NZTA Rolleston Access Improvements NoR - Package 1 Transport review

Abley Limited (Abley) has been engaged by Selwyn District Council (Council) to provide independent transport planning advice in respect of Notices of Requirements (NoR) in Rolleston prepared by NZ Transport Agency Waka Kotahi (NZTA) for the SH1 Rolleston Access Improvements Project.

Prepared for	Selwyn District Council
Project number	SDC-J084
Prepared by	Dave Smith and Mat Collins
Reviewed by	Dave Smith

Date issued	Status	Approved by
25 February 2025	A	Dave Smith

Figure 2.1 West of Dunns Crossing Plan Changes (Source: Selwyn District Council¹)

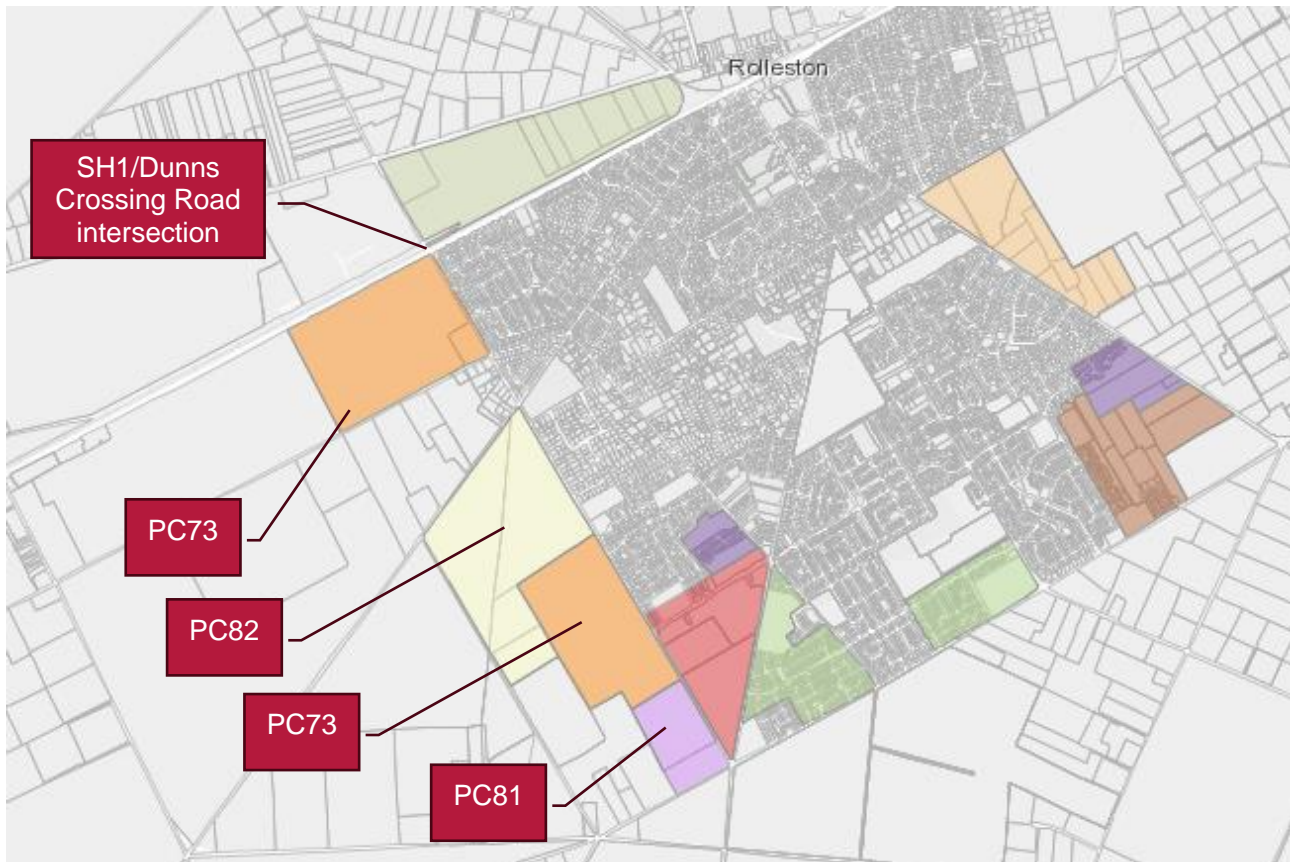
While the ITA states that the traffic effects of the CSI Property land were assessed through the respective Plan Changes, we note that the modelling for the rezonings assumed a different transport network than that assumed by the NoR. The modelling for the rezoning assumed:

- Two right turn lanes out of Dunns Crossing Road and a roundabout at Rolleston Drive south with two right turn lanes²
- Dual circulating lanes on all approaches of the SH1/Dunns Crossing Road roundabout³.

As the NoR only proposes a single circulating lane at the SH1/Dunns Crossing Road roundabout, we are concerned that the NoR design will not have sufficient capacity to accommodate future traffic volumes of the CSI Property land. Further, given some of the assessments for the CSI Property land also assumed a roundabout may be installed at the SH1 / Rolleston Drive south roundabout, they are also likely to have assumed lower levels of traffic demand through the Dunns Crossing roundabout compared to the NoR.

Figure 2.2 Potential method to incorporate a dual circulating lane for double right turn lanes from Dunns Crossing Road into SH1 (Source: S92 response dated 3 February 2025)

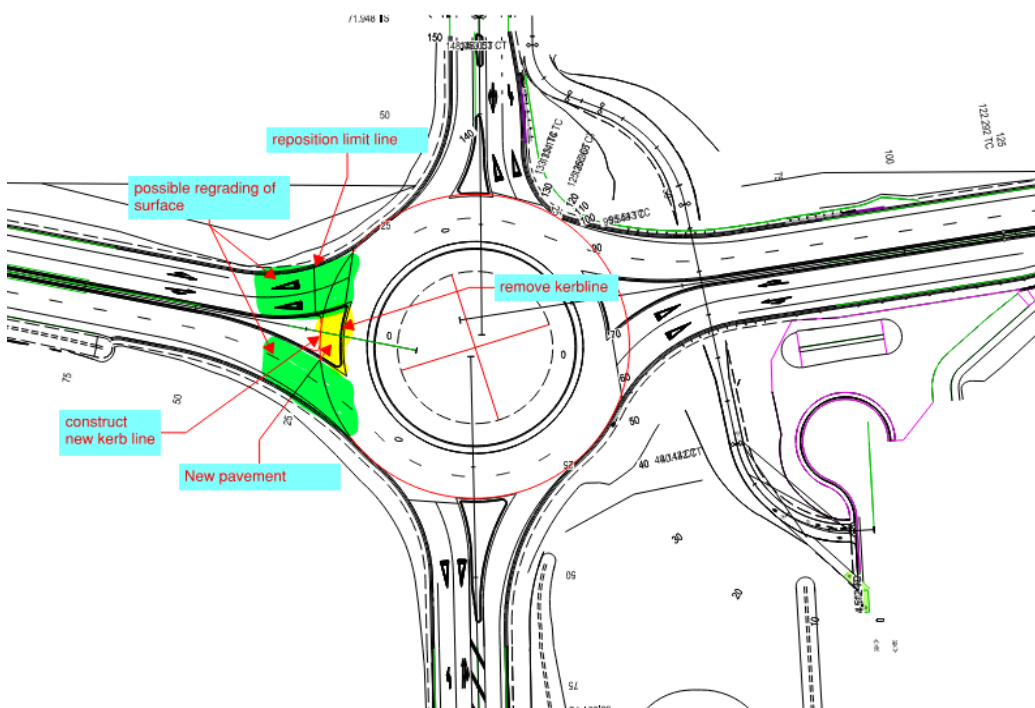
We are concerned that, if the single circulating lane is constructed as proposed in NZTA's design, this will necessitate future reconstruction of the intersection to provide the dual right lane arrangement needed to support development within the CSI Property land. This is likely to add additional construction costs and additional disruption to the transport network during construction. Further discussion is needed between NZTA and CSI Property Limited to ensure the constructed form of the SH1/Dunns Crossing Road intersection can accommodate future traffic demands.

In response to further information requests, Beca confirmed that a dual right turn and dual circulating lane could be provided within the NoR boundary, as shown in Figure 2.2. We are satisfied that the NoR does not foreclose the opportunity for the SH1/Dunns Crossing Road intersection to provide the traffic capacity needed to support development within the CSI Property land.

Figure 2.3 Potential pinch point for future path adjacent to SH1

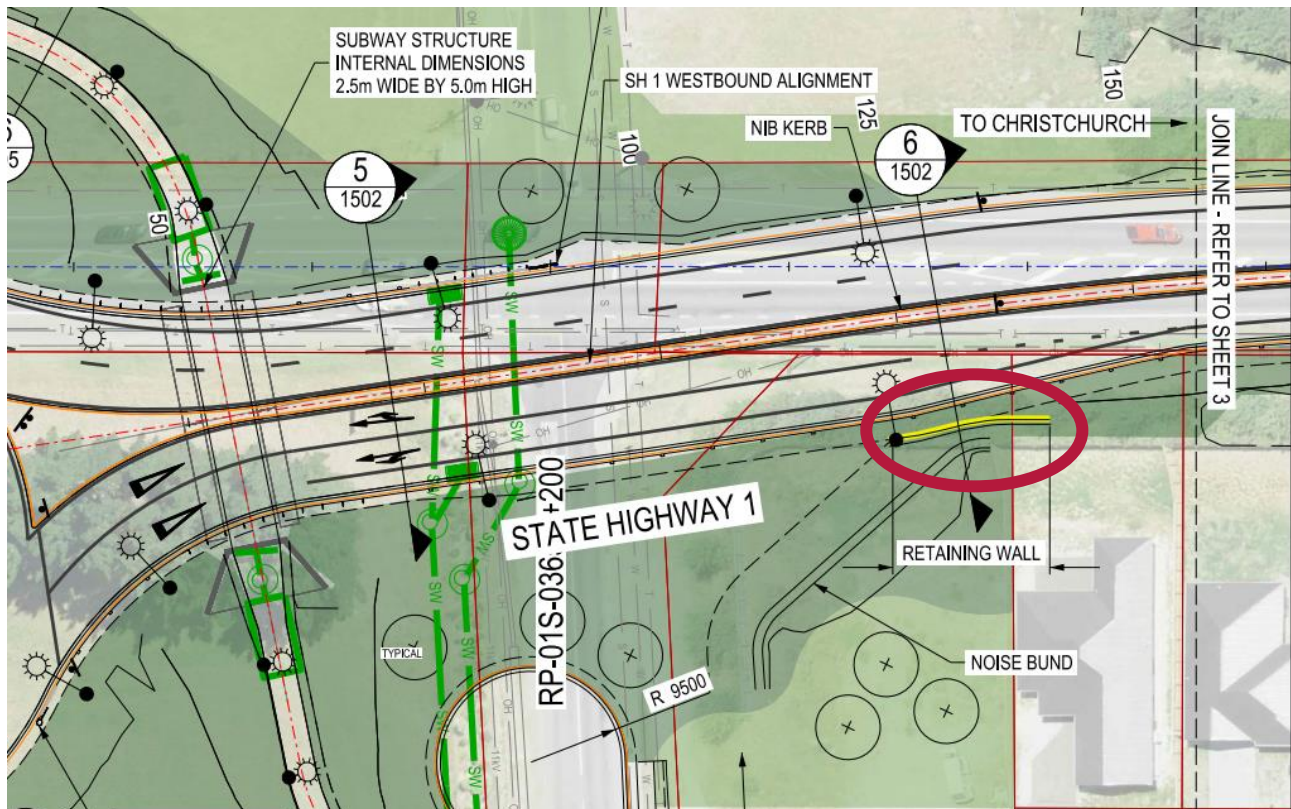
We identified that the SH1/Dunns Crossing Road roundabout may foreclose the opportunity to provide a walking and cycling path along the southern side of SH1, identified in Council's Walking and Cycling

Strategy 2018⁵, due to a 2m wide and 75m long pinch point between a roadside barrier and retaining wall, as shown in Figure 2.3.

Beca responded stating that NZTA and Council have indicated that they are not planning a future path connection in this location. We recommend that Council confirms this with its internal Strategic Transport Lead.

Figure 2.4 Dunns Crossing Road cul-de-sac and dead head

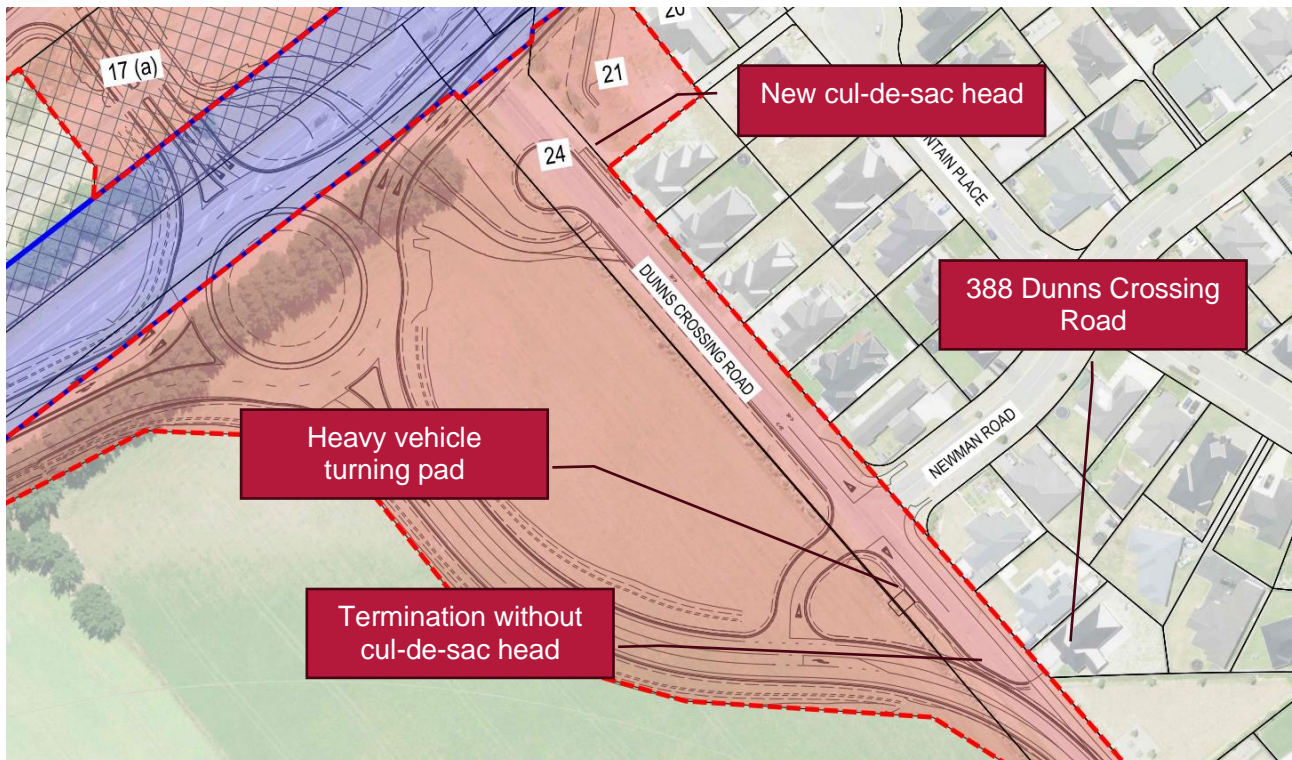
The proposed works include realigning Dunns Crossing Road and creating two short no exit sections of Dunns Crossing Road, as shown in Figure 2.4. The works propose a cul-de-sac turning head at the northern end, but there is no turning head at the southern end.

While appreciating that a southern cul-de-sac head would require a significant increase in land acquisition on the western side of Dunns Cross Road, we queried whether the proposed design was practical for future users. We requested:

- Heavy vehicle tracking to demonstrate how Council waste collection vehicles could manoeuvre within the southern section
- Light vehicle tracking for 388 Dunns Crossing Road to demonstrate whether occupants could manoeuvre into and out of the property
- Commentary on the practicalities of Council having to maintain/replace the carriageway of Dunns Crossing Road the vicinity of 388 Dunns Crossing Road, as the tapering of the carriageway may lead to accumulation of debris and difficulty for laying new carriageway surfacing.

Beca provided Drawing 3338703-10-CA-9021, showing the heavy vehicle turning pad located to the south. While this did not directly respond to our request for vehicle tracking assessments, we consider that the NoR boundary provides enough space to allow the design to accommodate vehicle tracking requirements, and that this can be addressed during detailed design including road markings and signage to confirm the purpose of this facility.

Regarding the maintenance of the carriageway, Beca responded stating that the design will be further discussed and agreed with Council during detailed design. We accept this response and consider that the designation boundary provides sufficient space for enable flexibility in the final design.
